Engineering Note

Title:	Hydro-View/HC-IV intermittent shut-down
Document reference (DRC):	EN0007 issue 10
Last updated:	22/01/98
Products affected:	Hydro-Views prior to model HV02, HC-IV prior to revision C
Author:	R.E.B. Holland
Search keywords:	Hydro-View, HC-IV, PTC, fuse, shut-down, fault
Summary:	This document describes how to replace a PTC device which is known to cause intermittent shut down of a Hydro-View or HC-IV operator terminal

FS1

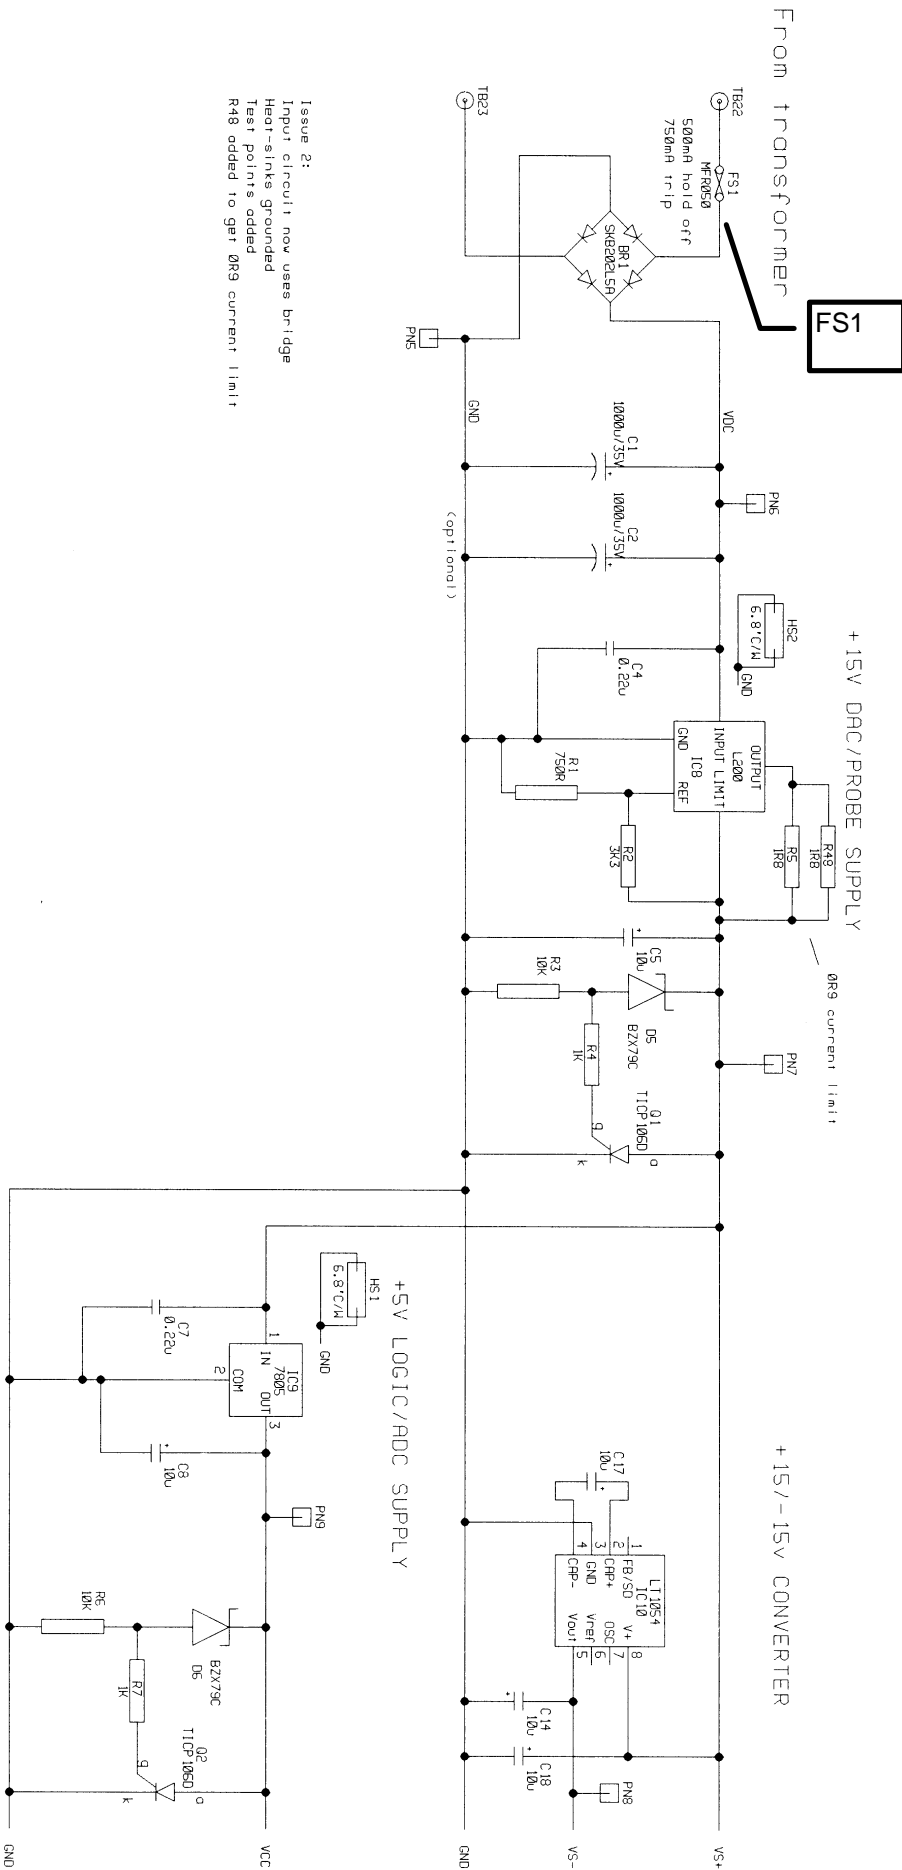
This is due to a current limiting device (Positive Temperature Coefficient (PTC) multifuse) tripping due to the high temperatures being achieved within the unit, especially with a sensor connected when the internal power dissipation is higher. We have evaluated several systems and have found that they will trip out after several hours at around 45°C ambient. Since the PTC fuse is essentially a device which exhibits a high impedance at elevated temperatures, it must either be up-rated or removed and replaced with an alternative type of device. Unfortunately, up-rating this is quite difficult if it is still to function as a current limiting device since a suitable value is unavailable.

Locate the PTC multifuse on the circuit board as FS1. This is indicated in the circuit diagram and PCB silk screen legend diagram later in this document.

Replace the multifuse FS1 with a wire link. This removes the problem and may be a convenient on-site modification, but this reduces the protection level particularly against short circuits on the 24Vdc supply output (terminals 13 and 17) which is then unprotected. The system retains short-circuit protection on the sensor supply however since this is effected by voltage regulator current limiting. If you are not using the 24V output, then this is a viable option.

Replace the multifuse FS1 with a 1A TR5 style PCB mounted antisurge (T) thermal fuse such as those from WICKMANN (e.g. part number 19732K 1A). This will prevent the problem occurring and will also offer some protection to the transformer secondary, albeit at the cost of replacing a fuse in the event of an 'accident'. It is recommended that FS1 be mounted in a suitable 2-pin socket (also available from WICKMANN) to assist replacement should the need arise. This approach has been adopted in production units from Hydronix.

To implement this modification, locate the multifuse in the top left-hand corner of the circuit board, immediately adjacent to the power supply connection and heat-sinks. Replace the multifuse with the chosen solution.
